Maintaining the PJM Region’s Robust Reserve Margins

A Critique of the PJM Report:

Energy Transition in PJM: Resource Retirements, Replacements and Risks

May 2023

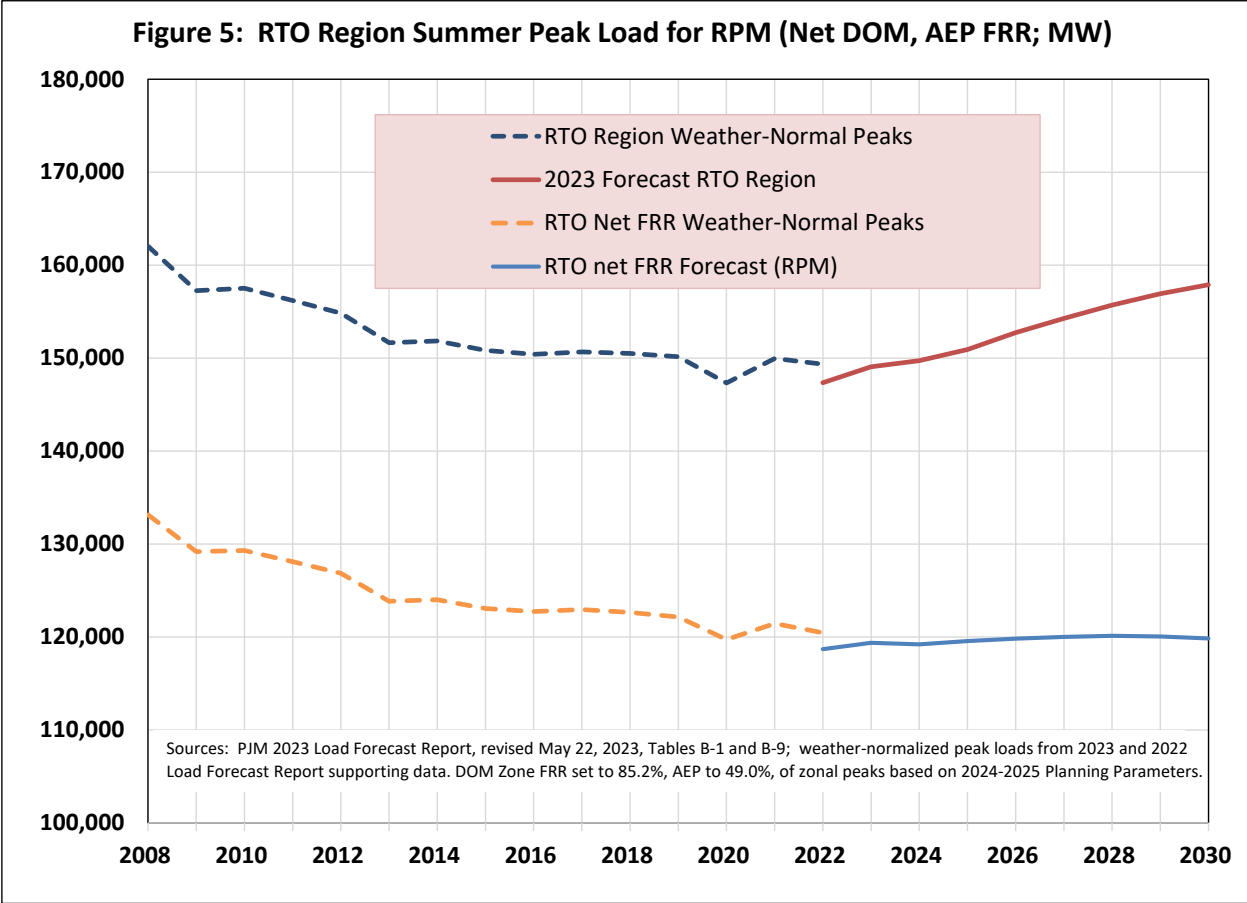
The PJM 2023 Forecast projects that RTO region summer peak loads will rise from recent levels under 150,000 MW to nearly 158,000 MW by 2030 (Figure 4).⁵⁹ However, since 2008 through 2022, RTO peak loads have actually been trending downward or flat, as shown in Figure 4.⁶⁰

Over many years, PJM has consistently (and incorrectly) forecasted that peak loads would rise.⁶¹ PJM has recently made changes to its forecasting methodology that should improve accuracy, and recent forecasts (before the 2023 Forecast) have been flatter and more consistent with the recent trend. The PJM 2023 Forecast only increases due to the inclusion of a highly speculative projection of future data center construction.⁶² While data center load in PJM was under 4,000 MW in 2022, PJM's 2023 forecast assumes it grows to over 25,000 MW in 2038.⁶³ Beyond about 2027 or 2028, this forecast of data center construction, which is provided to PJM by Dominion Energy and other utilities,⁶⁴ is speculative and not supported by contractual commitments. In the past PJM was unwilling to include in its forecasts speculative future data center construction beyond five years out;⁶⁵ PJM now accepts such speculation and relies on it as the basis for its forecast of rising rather than falling peak loads.

The lower, purple forecast line in Figure 4 shows PJM's forecast before the addition of the speculative data center amounts. This is PJM's forecast based on its load forecasting methodology and model, which includes a projection of future increases in data centers loads based on the historical trend in these loads.⁶⁶ With only such "embedded" data center growth, PJM's forecast continues to decline, consistent with the 15-year trend, although the decline is at a slow rate.
